PLOT PLAN

LOT 12 ✓
BENT GRASS RESIDENTIAL FILING No, 2 ✓
EL PASO COUNTY, COLORADO

8198 LEMON GRASS ROAD

DRAWING NAME
BG2-012

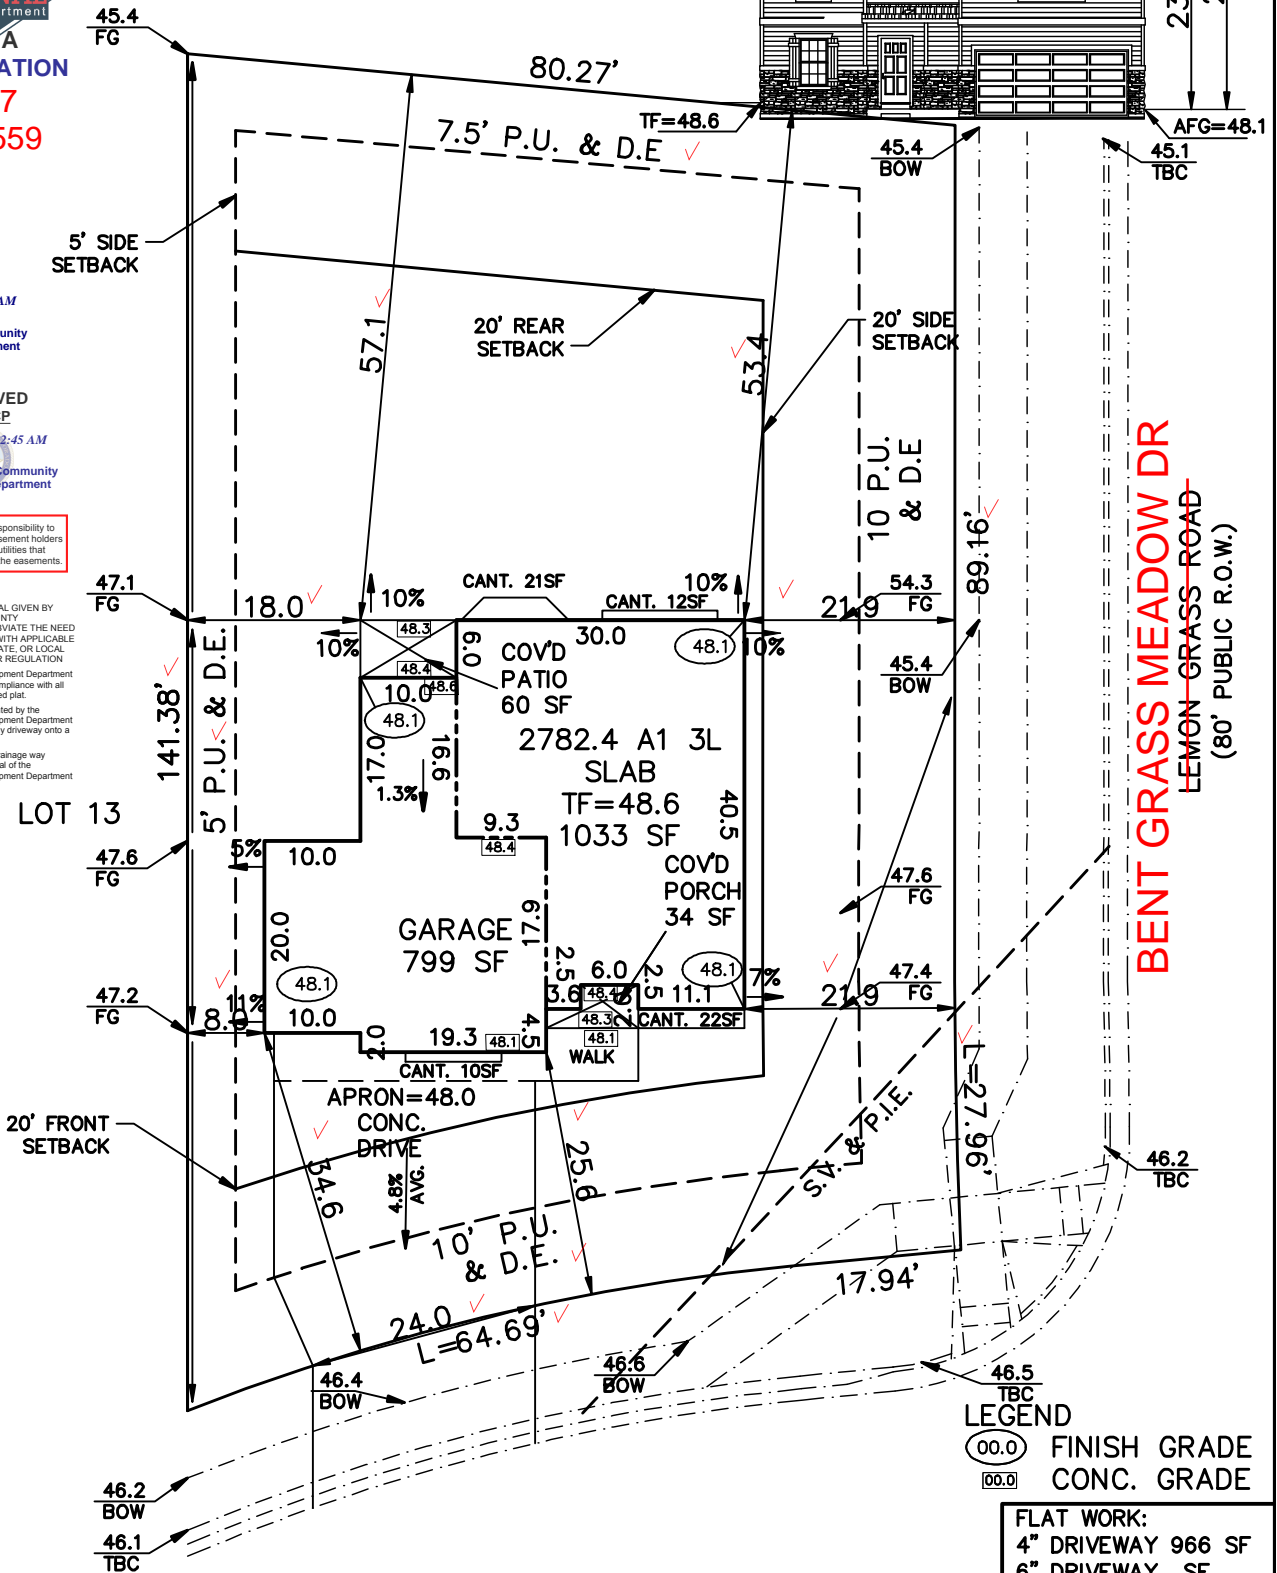
BENT GRASS MEADOW DR
~~LEMON GRASS ROAD~~
(80' PUBLIC R.O.W.)
